# Access Compliance Report

## Public Rights-of-Way

### (Curb Ramps)

Intersection ID: 3740	Main Street: CHESTNUT_KNOLL_LN	Cross Street: DAVIS_LAKE_PY	Location: S
ADA ID: 9CAF9109A4B4	Ramp Type: Perp	Initial Pass/Fail: Fail	Overall Compliance: No
Severity Score: 10			
Codes/Mitigation Info/Possible Solution		Field Measurements/Component Compliance

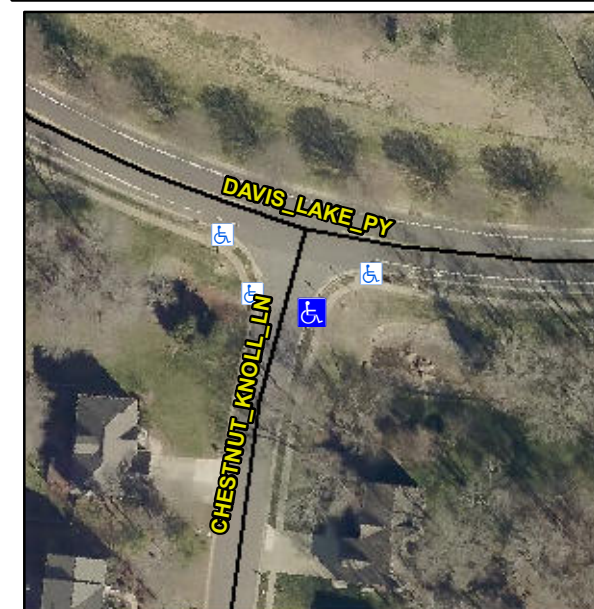
**Not Found, R304.5.1, R304.5.3**

Compliance	Description	Data	Compliance	Description	Data
N/A	Ramp Length (in)	55.0	Yes	Ramp Slope (%)	5.5
No	Ramp Width (in)	46.0	No	Ramp XSlope (%)	2.1
N/A	Flare Type LT	N/A	N/A	Flare Type RT	N/A
N/A	Flare Slope LT (%)	N/A	N/A	Flare Slope RT (%)	N/A
N/A	Flare Traversable LT?	N/A	N/A	Flare Traversable RT?	N/A
N/A	Landing Length (in)	N/A	N/A	DWS Provided?	N/A
N/A	Landing Width (in)	N/A	N/A	DWS Contrast?	N/A
N/A	Landing Slope (%)	N/A	N/A	DWS Length (in)	N/A
N/A	Landing X Slope (%)	N/A	N/A	DWS Full Width?	N/A
N/A	Landing Curb? (Y/N)	N/A	N/A	DWS Offset (in)	N/A
N/A	Shared Landing?	N/A			
N/A	Gutter Ponding?	N/A	N/A	Gutter Slope (%)	N/A
N/A	Gutter Lip Ht (in)	N/A	N/A	Gutter X Slope (%)	N/A
N/A	Painted X Walk1?	No	N/A	Painted X Walk2?	N/A
	X Walk 1 Direction	To NW		X Walk 2 Direction	N/A
N/A	X Walk 1 Width (in)	N/A	N/A	X Walk 2 Width (in)	N/A
	X Walk 1 Slope (%)	5.9		X Walk 2 Slope (%)	N/A
	X Walk 1 X Slope (%)	1.4		X Walk 2 X Slope (%)	N/A

**Remove & Replace Entire Ramp.**
